**DECISION NOTICE FOR OPERATIONAL WORKS ASSOCIATED WITH AGED
CARE FACILITY - JOHNSTON ROAD MOSSMAN**

**DECISION NOTICE FOR OPERATIONAL WORKS ASSOCIATED WITH
AGED CARE FACILITY - JOHNSTON ROAD MOSSMAN**

Operational Works (Engineering) excluding Landscape and Lighting Works

CENTRELINE ENTRY ROAD LONGITUDINAL SECTION

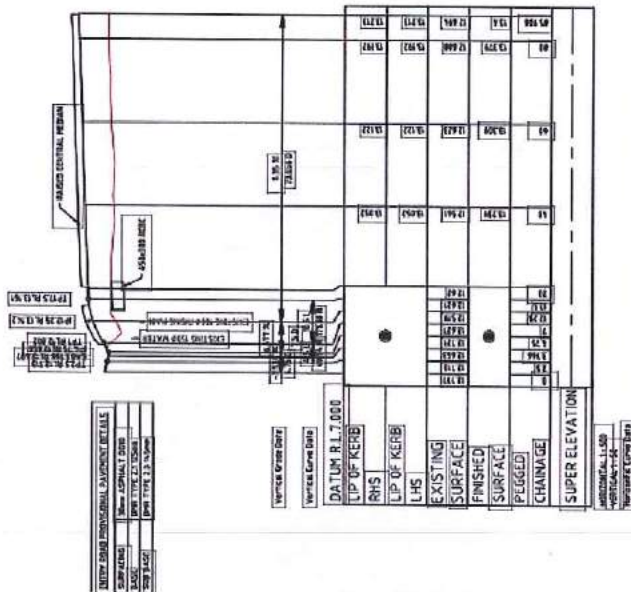
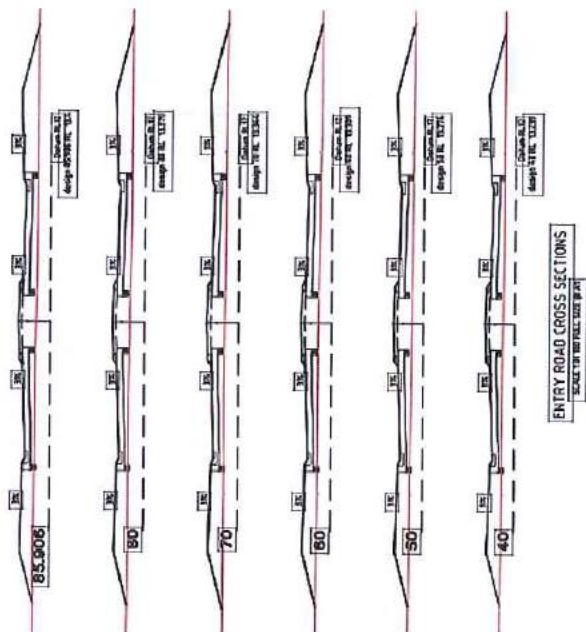
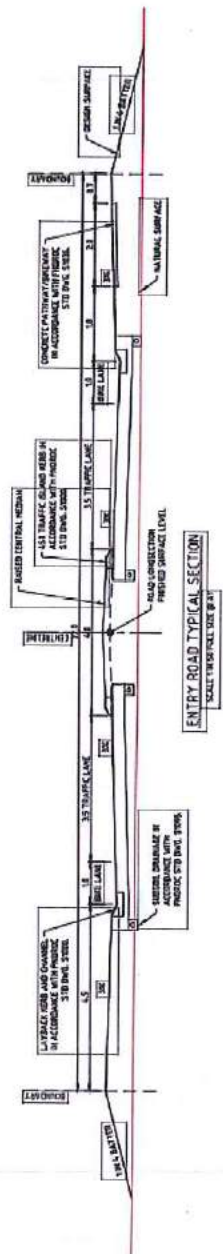
- a. Roadworks in Johnstone Road are to be constructed generally in accordance with STP Consultants drawings.
- b. Entry Road; Subject to the stormwater redesign under condition 3a, the entry road grading is to be revised to provide the minimum vertical curve geometry at the intersection with Johnston Road. In the event the revised road grading requires relocation of the kerb inlet pits, these are to be documented on revised drawings submitted to Council.

- c. The grading of the entry road is permitted to fall to the north and discharge into the balance land provided that the kerb invert levels are free draining to the surface and normal flows are directed to the piped drainage system. The junction pit approximately 14m north from the end of the Entry Road is to be constructed as an FNQROC Type B field inlet pit. Surface runoff from the end of the road must be directed to this pit;

ALTERNATIVE STORMWATER CONCEPT

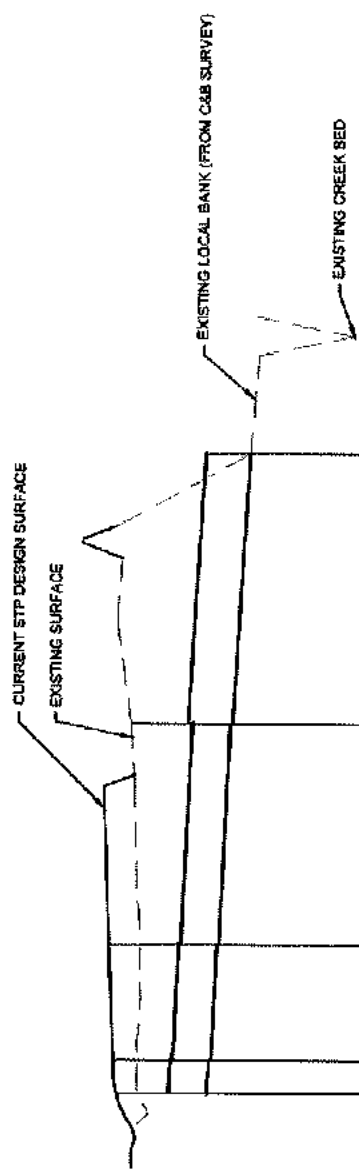
- a. Provide amended "for construction" drawings for an underground pipe system capable of conveying the 5 year ARI rainfall event for the local rainfall event. The "for construction" drawings must document the underground pipe system generally in accordance with the Alternative Stormwater Concept shown in Appendix B. Council will accept that the downstream tail water level for design of this system can be set at obvert of pipe for a pipe invert of 10m AHD per the Alternative Stormwater Concept.

- b. Council does not require the piped stormwater system to convey the minor event flows when the hydraulic grade line exceeds the above scenario; that is, when Marr's Creek is in flood (the 12 hour rainfall event).

- c. Council does not require an additional culvert crossing at the intersection of the Entry Road and Johnston Road with the implementation of the above alternative stormwater system. As per normal QUDM requirements flows greater than the 5 year ARI and up to the 100 year ARI local design event must be shown to overtop the road or run along the road.
